LATE REPRESENTATIONS SCHEDULE
PLANNING COMMITTEE – 10th JANUARY 2018

PAGE NO. 1	APPLICATION NO. 15/2960/MNR
ADDRESS:	30 SPRINGFIELD GARDENS, MORGANSTOWN, CARDIFF
FROM:	Mark Drakeford AM and Kevin Brannan MP
SUMMARY:	<p>The AM and MP write on behalf of a number of local residents in relation to the planning application and refer to their previous correspondence on the matter.</p> <p>They refer to multiple issues with this application, including evidence of a potentially serious flood risk. They request a full site meeting prior to any determination. Having visited Springfield Gardens, they are convinced that it is only possible to understand the issues at stake in the application by being able to visualise the particular topography of the site. They comment that the site is overlooked by the Ravensbrook development and that residents in this part of Morganstown will also feel the direct impact of any development. It is their firm opinion that a site visit must be undertaken before any consideration of the planning application by the committee can take place. They also consider that it would be very important that any site visit is made known to residents in that area and that they

Extract from 'Proposed Site Plan - Sheet 1'

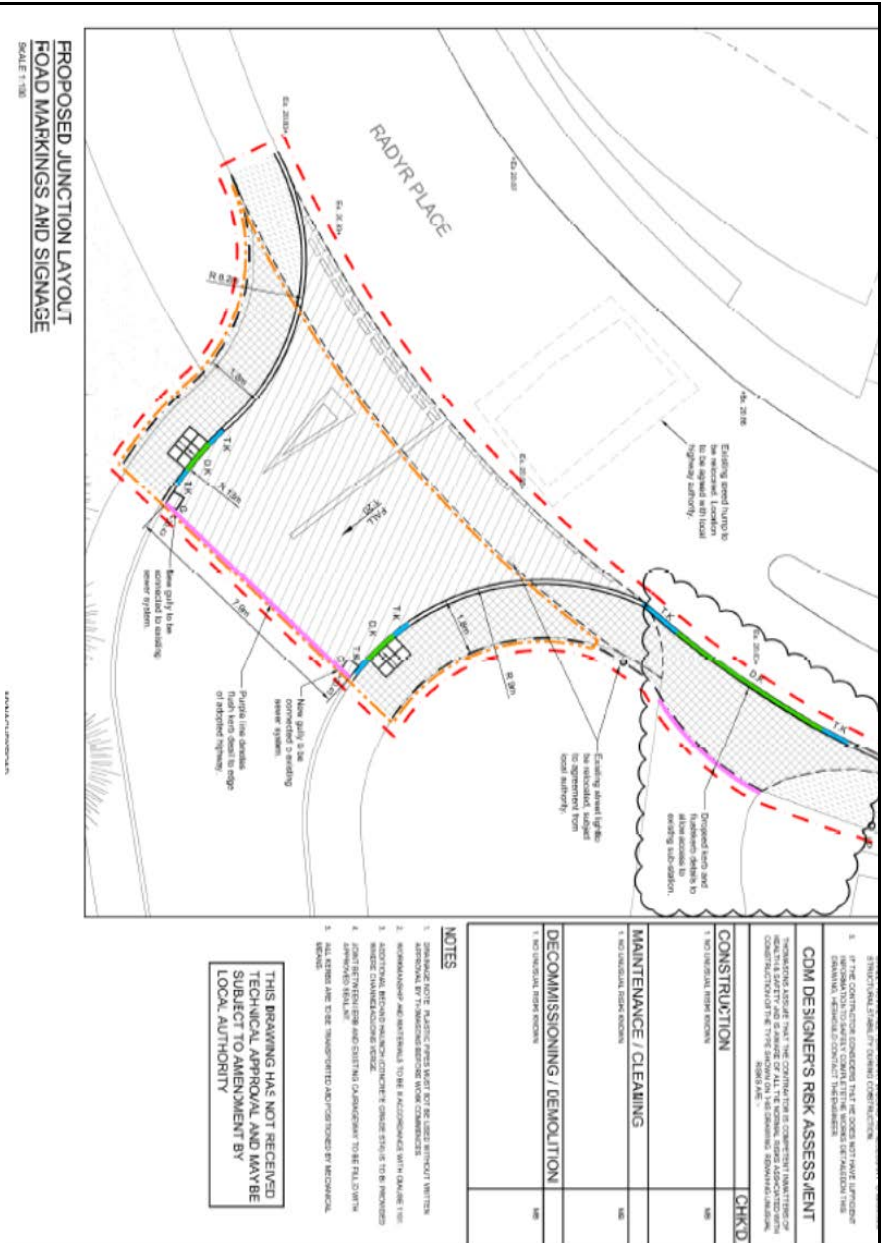
PAGE NO. 111	APPLICATION NO. 17/01963/MNR
ADDRESS:	LAND OFF MYNACHDY ROAD, MYNACHDY
FROM:	Mr Iain Claridge
SUMMARY:	<p>Ownership and Safety</p> <p>The only existing plan for the new access point to the proposed development is that submitted by the developer as 17/00985/MR in June 2017 in fulfilment of reserved matters from application 11/00863/DCI of 2011/2016.</p> <p>This junction plan shows the closure of the present access to the Institute and the building of a new junction at the current speed bumps on the bend of Radyr Place.</p>

This is some way on from the **current access**, the white markings of which are in line with the bollard on the traffic island.

It is principally to consider the safety and suitability of this plan that you were petitioned to make a site visit before determining application 17/01963/MJR and it is due to the danger and confusion of this junction plan that you are asked to decline planning permission. The developers` agents Geraint John submitted to you 7 December a letter refuting the petition and the objections of all elected representatives for Gabalfa and Llandaff North in the following terms with regard to the junction :

Here is the junction shaped as in 17/00985/MJR but with its mid-point close to the tip of the traffic island. **This is not the same spot as access through the current speed bumps and street light on the Radyr Place bend.**

<p>REMARKS:</p>	<p>A condition controlling the design of the site access/junction is proposed, as was previously the case within the 11/00863/DCI application. The location of the proposed access point would now be in the approximate location of the existing access point, albeit being widened. The proposed access would form a single shared access serving the student development and community centre proposal.</p>

The Operational Manager – Highways confirms that the access arrangement shown in the application would be acceptable (subject to detailed design and approval condition). The proposed access arrangement (17/01963 - L(01)021 Rev A) would facilitate access to the proposed student accommodation, institute and electricity substation. The provision of a single access point would be preferable in safety terms.

The visibility splay from the proposed junctions provides adequate minimum stopping distance (50m) for a HGV in wet conditions for vehicles traveling at 30 mph (in accordance with Manual for Streets 2).
